The City of Spartanburg Design Review Board

AGENDA

July 2, 2024, at 5:30 P.M.

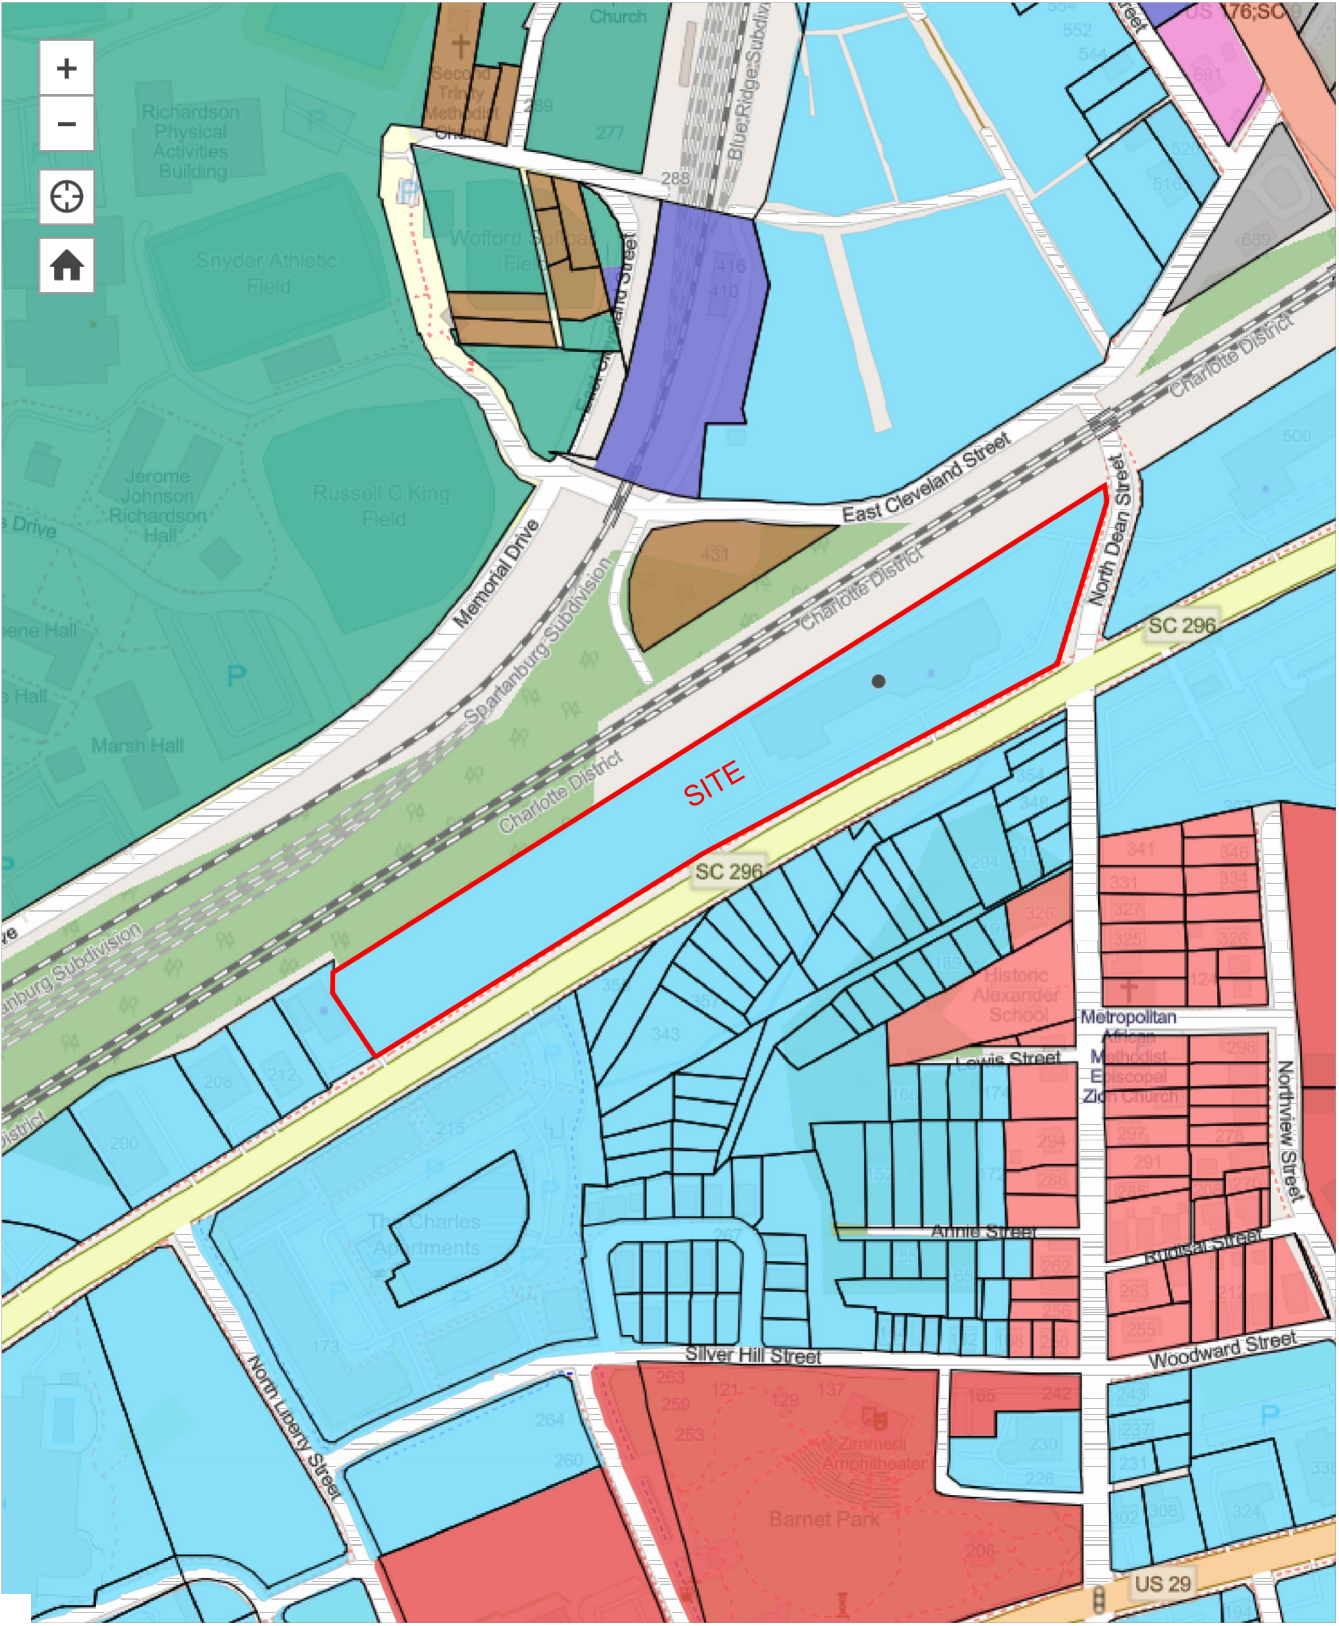
- **Streetscaping:** The current sidewalk and tree planting area is substandard with a lack of street trees and a narrow sidewalk. Striping for on-street parking in the outside lane of Daniel Morgan was recently installed and is being utilized. Also, there are overhead utilities which will preclude the installation of canopy streets in the streetscape but would permit understory trees such as Crepe Myrtles however, there does not appear to be adequate soil area to support their installation without losing a substantial amount of parking across the frontage. As an alternative, we encourage the exploration of curb extensions into the pavement of Daniel Morgan in order to install the trees. (See image below)

1 Daniel Morgan Elevation
3/16" = 1'-0"

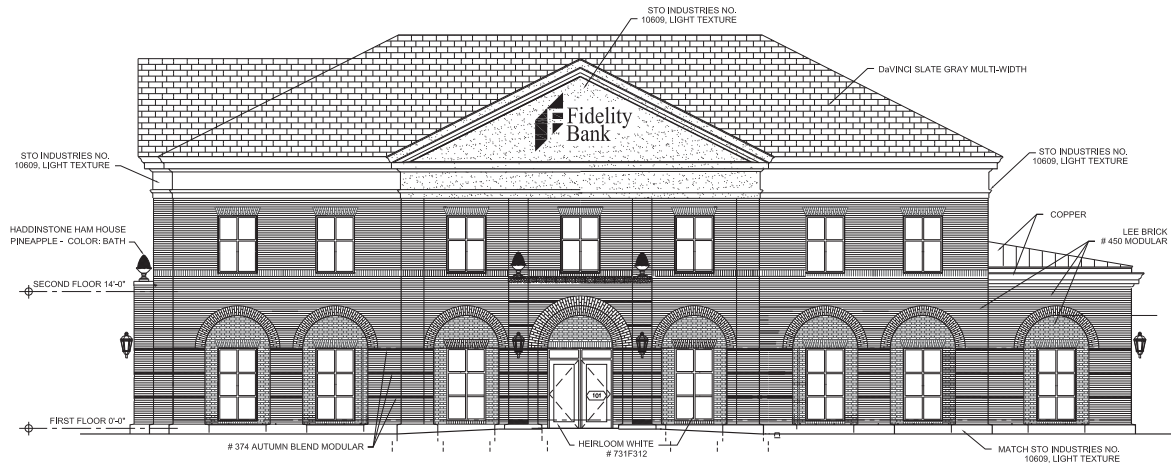
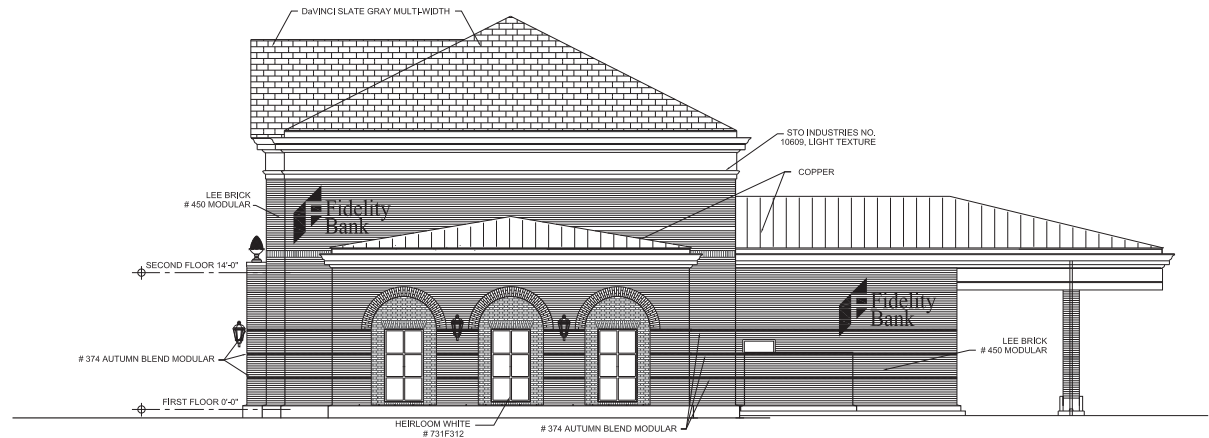
- **Ground Level Transparency:** The applicants have requested an exception to the minimum transparency. No calculations have been provided as to what is in the current proposal so it's difficult to determine what mitigating elements can be provided. The reasons for the exception provided was so that they could keep to the brand but as buildings in the city often have many lives beyond the initial tenant, and the context of this site being at a prominent entry to the downtown, we do not think that should be an adequate reason to deviate from one of the key design standards that promotes pedestrian activity in the downtown.

At a minimum we would encourage a design adaptation of the one-story secondary element along Daniel Morgan Avenue. As the overall design aesthetic draws from a residential colonial revival vernacular, it would not be uncommon to see this secondary element designed as a sunroom with more extensive windows. As a corner element, it would contribute to the overall porosity of both facades, while also being complimentary to the overall architectural brand of the bank.

- The use of a Common Yard frontage be permitted subject to the inclusion of landscaping around the perimeter of the building; and
- The minimum ground floor transparency be reduced below the required 60% with a mitigation that considers the design of the one-story corner element as a “sunroom” feature to expand the use of windows along the ground floor or a similar mitigating design element.
- The redesign of the driveway onto Daniel Morgan Avenue as a pedestrian-friendly crossing through reduction the overall radii and reduction of the splitter island.
- An exception granted by the DRB, permitting a second drive-thru facility less than 500 feet from an existing one, only subject to the change in the driveway configuration on Daniel Morgan Avenue.
